PROJECT TITLE  
**Domremy College Solais Project**

### STORMWATER MANAGMENT CONCEPT PLAN – CIVIL ENGINEERING

## **RE: DA2018/0076 DOMREMY COLLEGE: RESPONSE TO REQUEST FOR ADDITIONAL INFORMATION**

**RE: DOMREMY CATHOLIC COLLEGE - 121 FIRST AVENUE, FIVEDOCK (DA 2018/0076)  
LETTER OF RESPONSE TO COUNCIL**

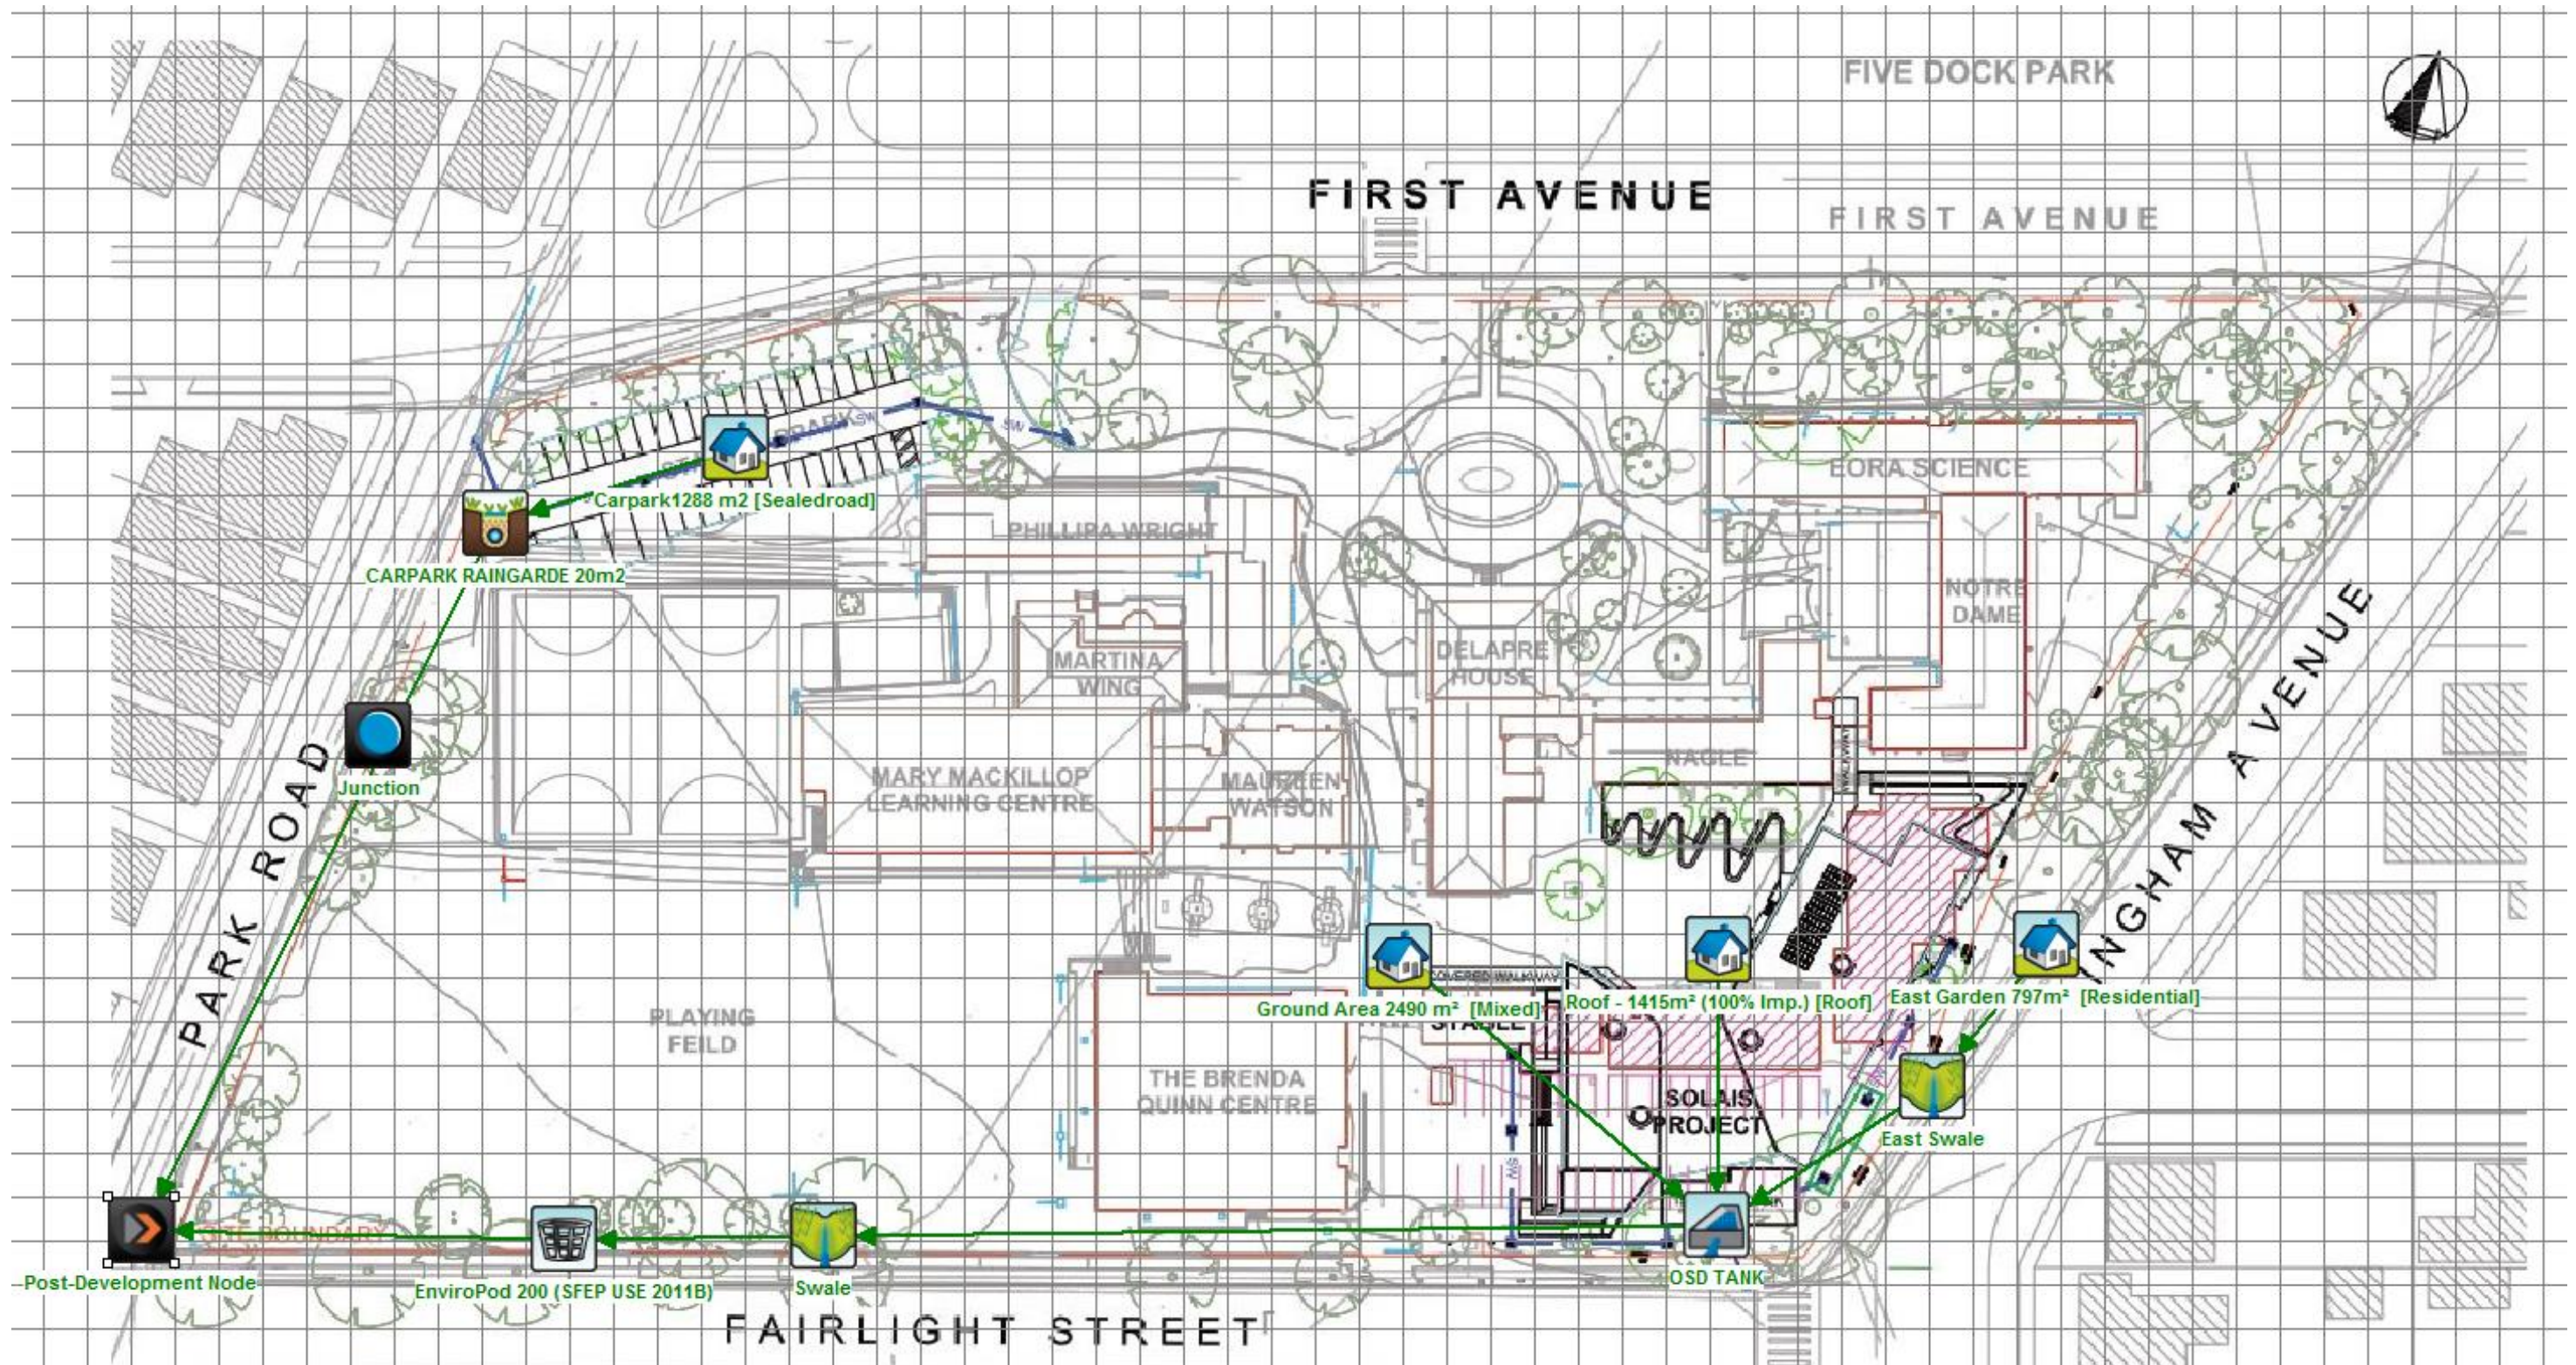
Sediment and Erosion control measures and proposed discharge from sediment basins shall be incorporated in the Stormwater Concept Plan	Refer to DWG CV-0202 & CV-0400
<b>Driveway Access</b>	
Longitudinal section along the extreme wheel path of proposed driveway in First Avenue. The section shall extend from the centre line of the roadway and shall include all gradients including footpath cross fall to be at a maximum of 2.5%, change of grade and grade transition details and levels. It shall also include a standard layback crossing with a maximum of 100mm level difference from the invert of the gutter to top of layback. Layback levels shall be consistent with the detail survey levels.	Refer to DWG CV-0512 DRIVEWAY SECTION and Traffic Statement
The driveway profile shall also demonstrate compliance with the scraping provisions of AS/NZS 2890.1:2004 based on the 85th percentile vehicles ground clearance templates.	Refer Traffic Statement

A sedimentation and erosion control plan has been prepared for the site works, and is provided in Appendix B. The plan includes measures such as: sediment fences surrounding disturbed areas to capture sediment runoff and a truck shaker tray at each point of access to the work area. The measures to be adopted are summarised in the Table 2.

UPDATED DRIVEWAY SECTION

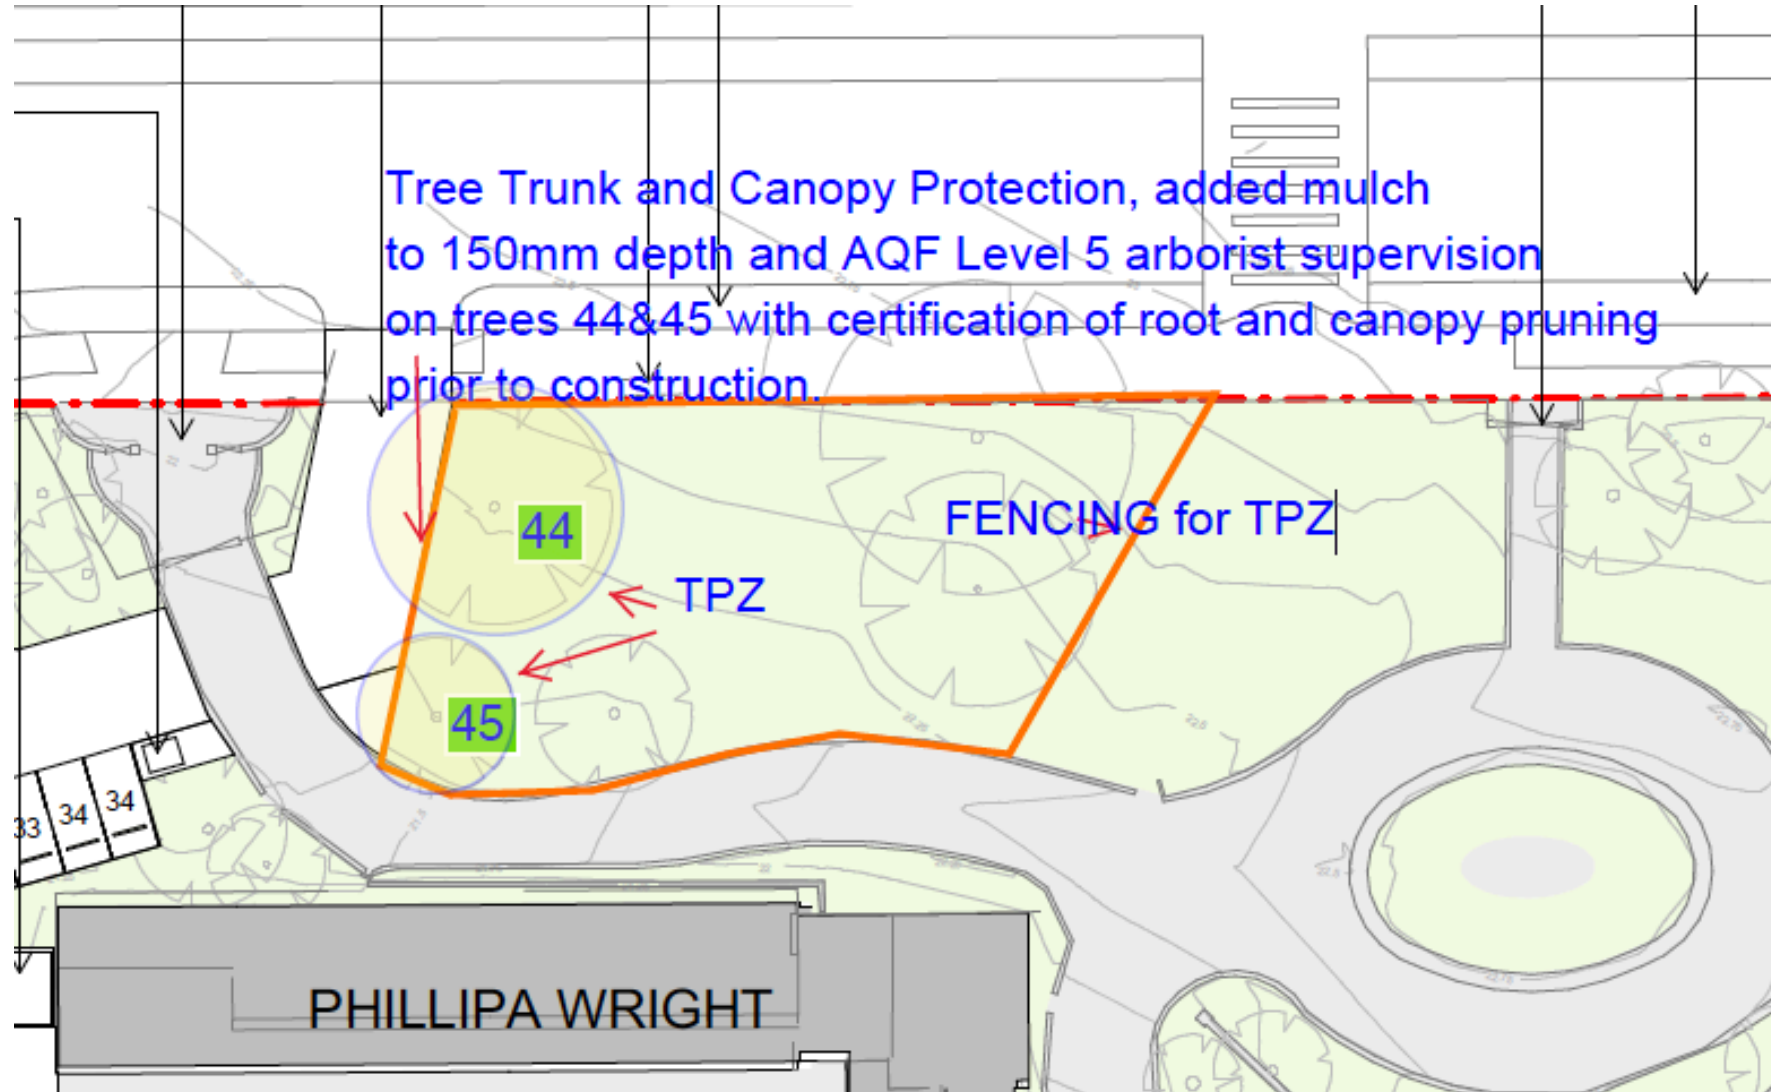
Longitudinal sections are to be provided along the extreme wheel path of proposed driveway in First Avenue. The section shall extend from the centre line of the roadway and shall include all gradients including footpath cross fall to be at a maximum of 2.5%, change of grade and grade transition details and levels. It shall also include a standard layback crossing with a maximum of 100mm level difference from the invert of the gutter to top of layback. Layback levels shall be consistent with the detail survey levels.

Separate to the above, we note that comments have been received from Council's tree officer and heritage advisor advising that the proposed driveway onto First Avenue should be relocated to ensure that Tree 38 is able to be retained. In response, we note that the alignment of the First Avenue driveway and internal roadway have been reconfigured to ensure that these are clear of Tree 38 and importantly, that Tree 38 is able to be retained. The revised arrangements are shown by the amended Site Plan, prepared by Hayball, included in **Attachment 3**.
